**COUNTY OF SAN MATEO  
PLANNING AND BUILDING DEPARTMENT**

**SUBJECT:** STAFF REPORT ADDENDUM: Consideration of a Coastal Development Permit, Use Permit, Variance, and Design Review Permit, pursuant to Sections 6328.4, 6500, 6530, and 6565.3, respectively, of the San Mateo County Zoning Regulations, and a Grading Permit, pursuant to Section 9283 of the County Ordinance Code, for the construction of a new 10,178 sq. ft. fire station to replace the existing Fire Station 44, on a 21,695 sq. ft. property located at 501 Stetson Street in the unincorporated Moss Beach area of San Mateo County. A Variance is requested for a reduction in the front setback and an exceedance of the maximum floor area of the zoning district. The project is appealable to the California Coastal Commission. In conjunction with the requested permits, it is recommended that the Planning Commission determine that the project is categorically exempt from California Environmental Quality Act (CEQA) pursuant to CEQA Guidelines Section 15302.

County File Number: PLN 2023-00311 (Coastside Fire Protection District/Duncklee)

DESIGN DEVELOPMENT
<b>PHOTOMETRIC SITE PLAN</b>

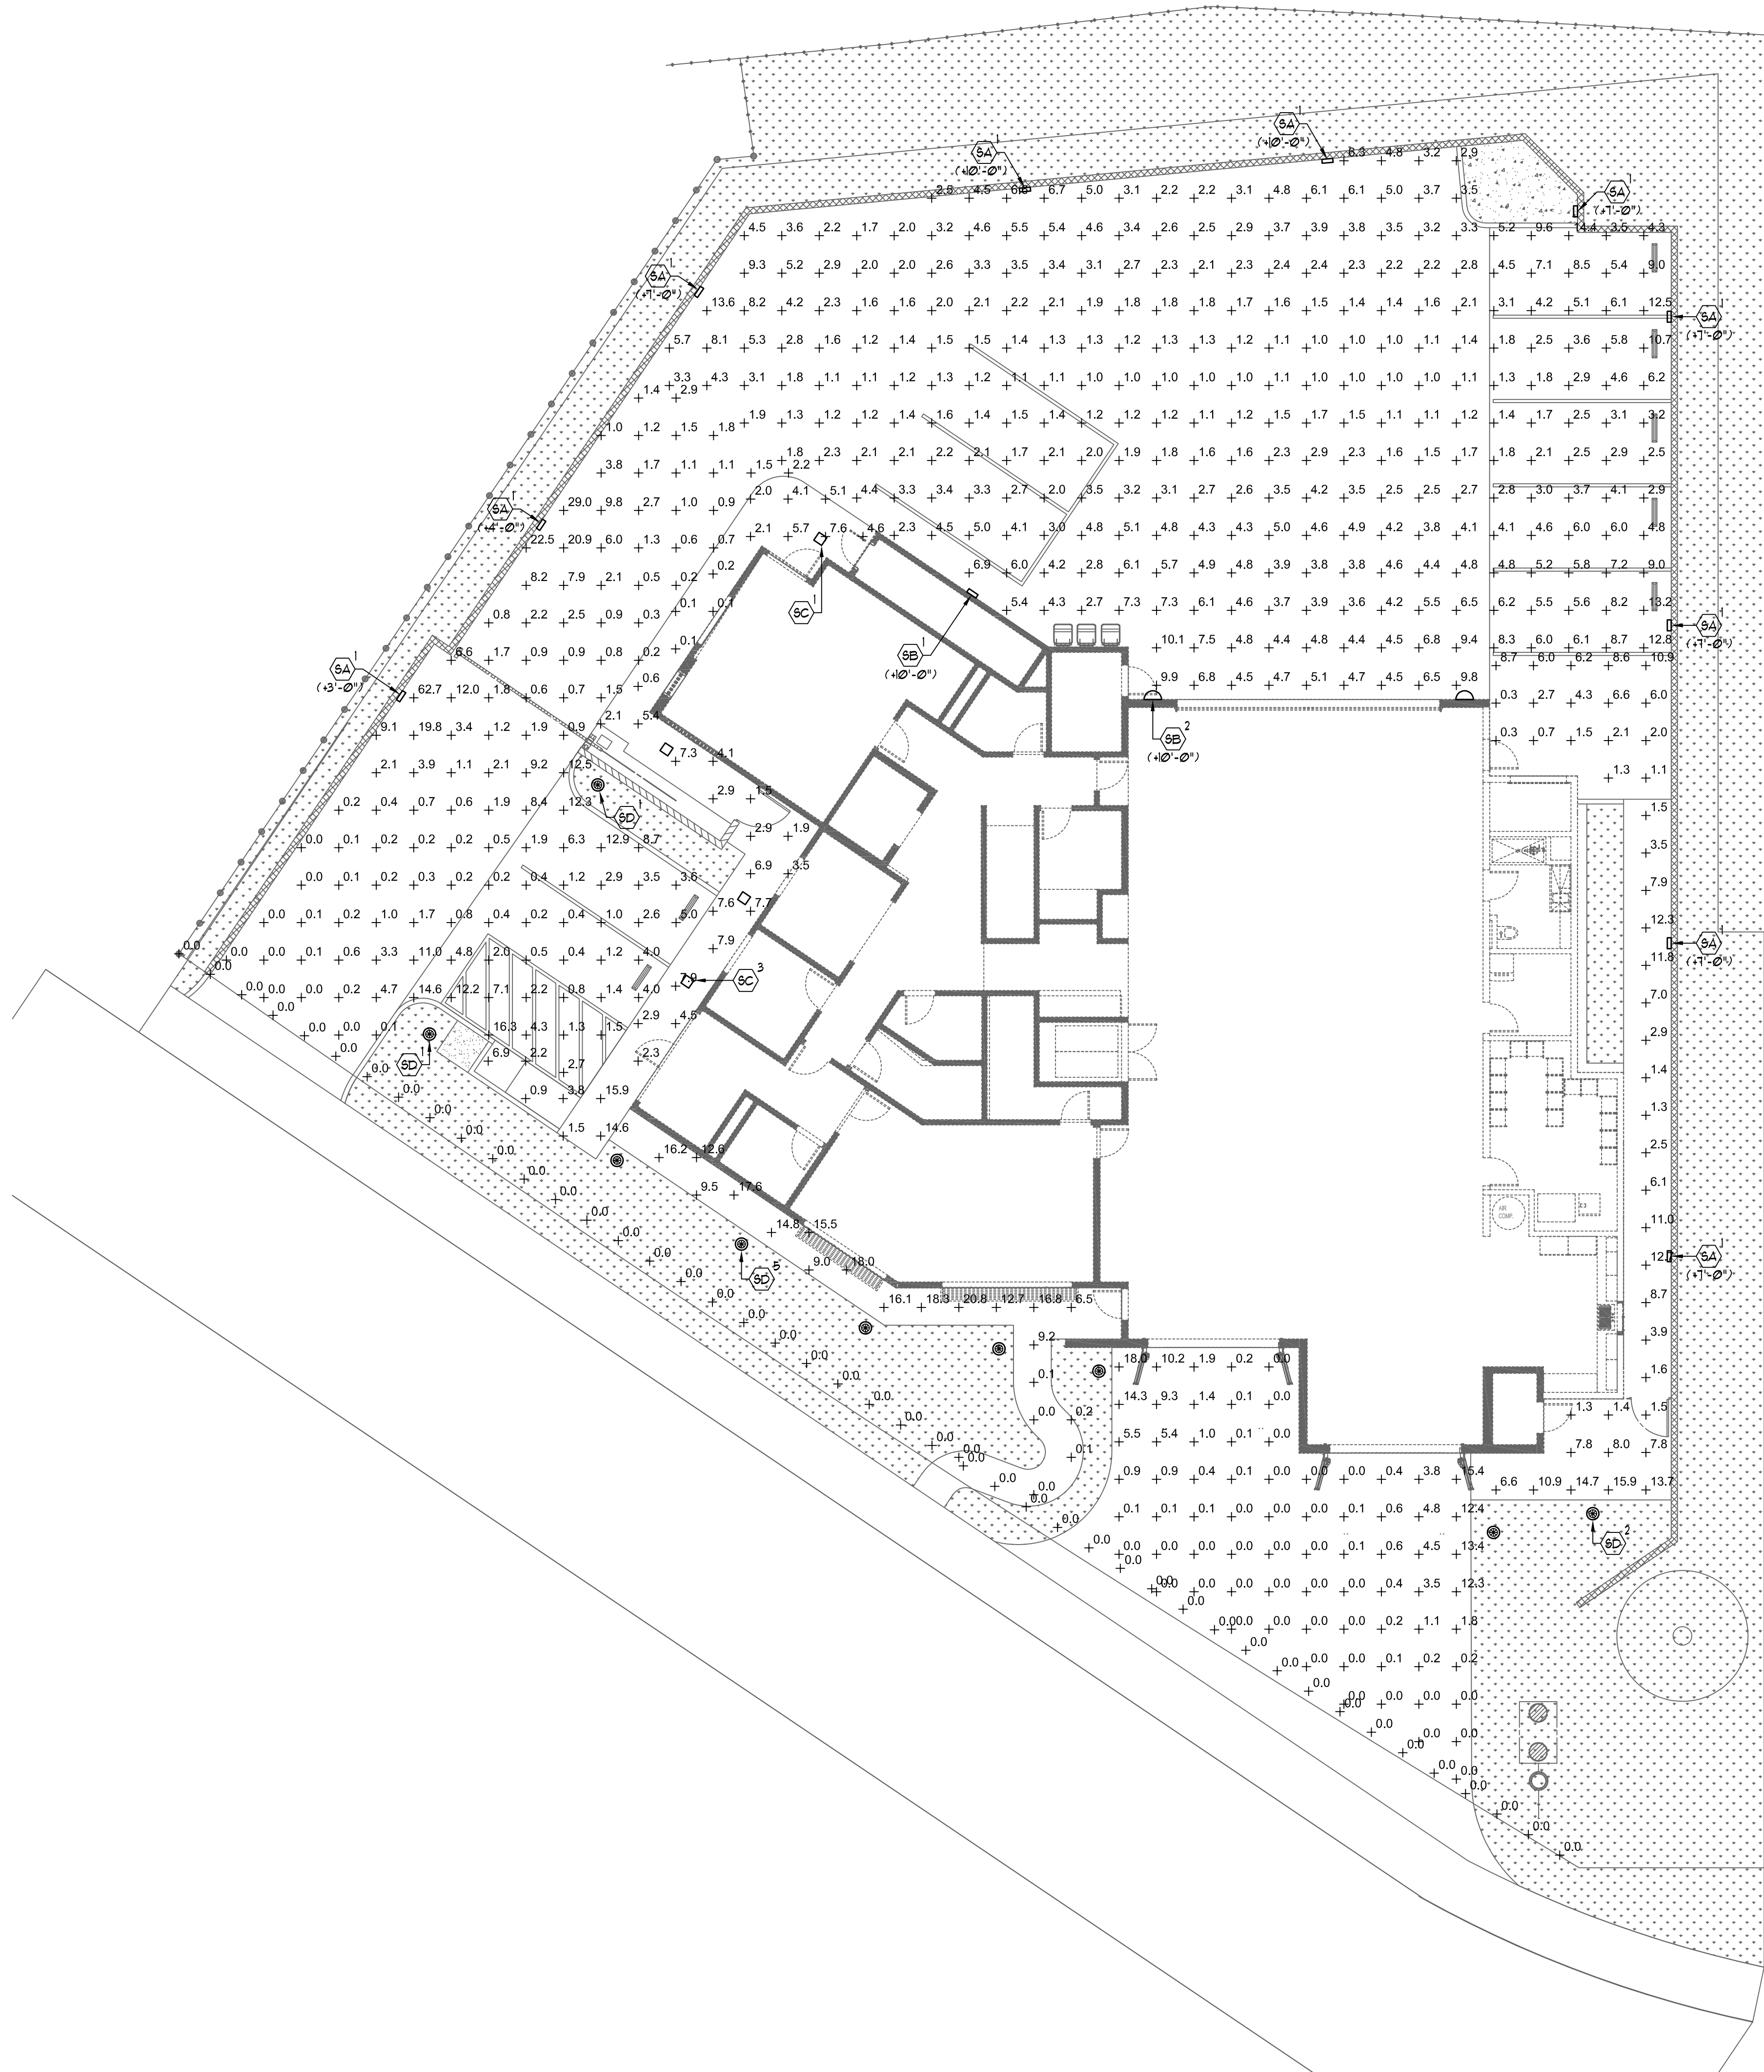
COMMENT: Requested additional information, such as lighting specs and updated lighting plan

**COMMENT:** Public health concerns related to noise and lighting.

RESPONSE: See updated light plan (E1.1P) and data fixture sheets.

1. Lighting - Very careful attention has been given to the lighting design of this station. The feedback received from MCC was understandable and has influenced our redesign. Please reference the updated site lighting plan on sheet E1.1P. The intent of the Fire District is to blend in with existing conditions and avoid any harsh light that would disturb neighbors and wildlife as noted by the MCC, while still meeting at least the minimum lighting requirements needed to safely light the site. Our updated design includes lighting fixtures mounted on the retaining walls preventing light from spilling over into the neighboring houses. However, in the case of an emergency it is vital that the fire station has the proper lighting to help ensure the community is safe. We included pole mounted lights in the back to ensure that the station is properly lit during an emergency. The emergency lighting will be on a key system and only be activated during emergencies. Please understand that the site lights have been reduced to minimize light spill with the wall mounted lights. Also, the light to the left of the response drive has been removed and replaced with a light bollard.
